KRB STUDY REQUEST 3: *Enjoyable Angling Flows*

RESPONSE TO COMMENTS

KRB SP-3: ENJOYABLE ANGLING FLOWS UPDATED STUDY PROPOSAL

The Drought Killed about Half the Fish; Fairview Dam and KR3 Killed (Almost) All the Rest

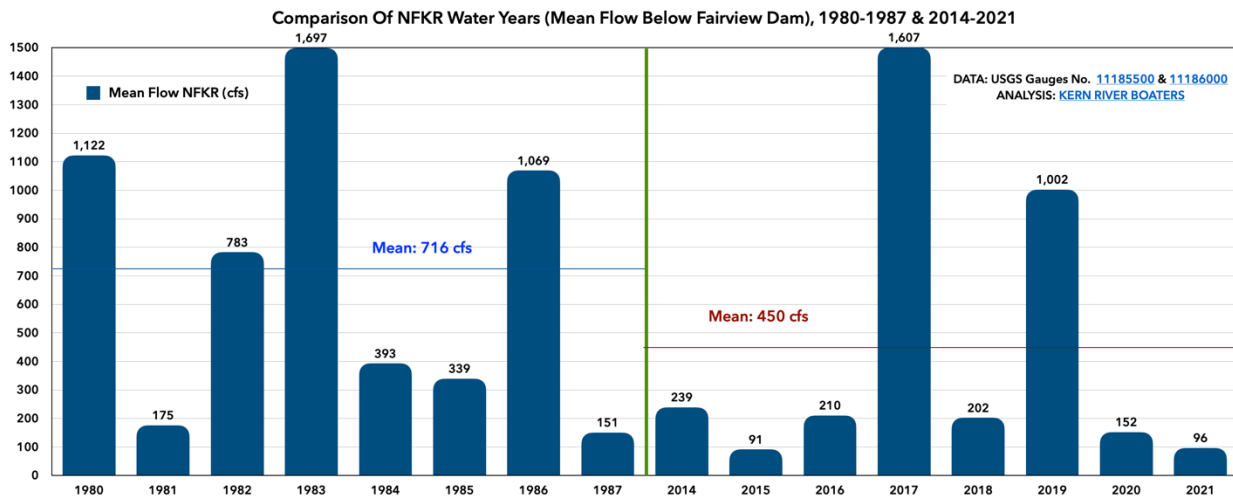
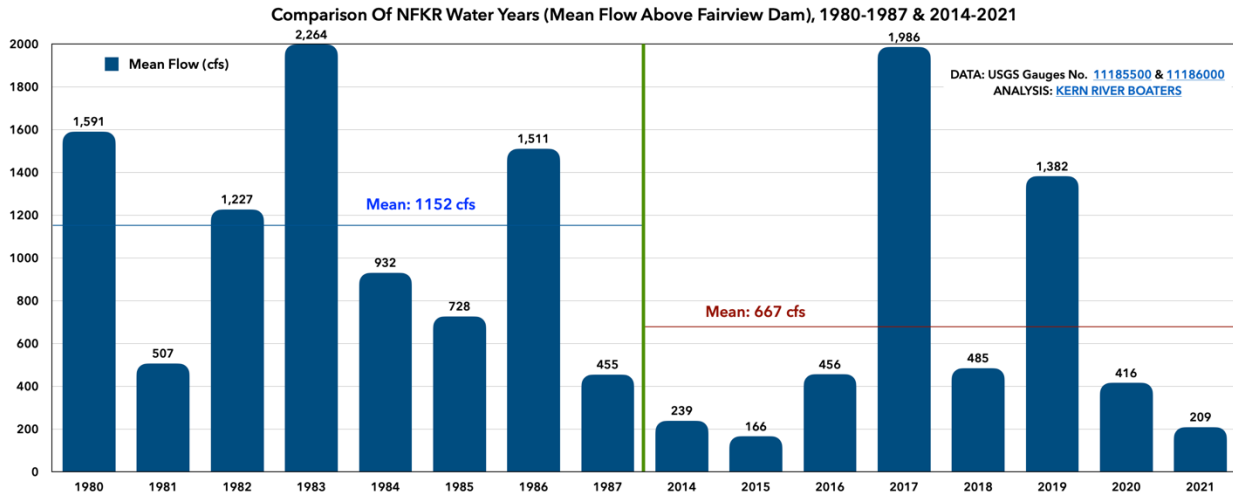
(2) Edison’s 2016 fish monitoring study showed an incredible difference between the effect of the drought on trout above and below Fairview Dam: trout above the dam suffered a 50% reduction, while below suffered a 95% reduction. The inference is undeniable: project operations killed (almost) all the trout:

It should be no surprise that anglers find this fishery unenjoyable.
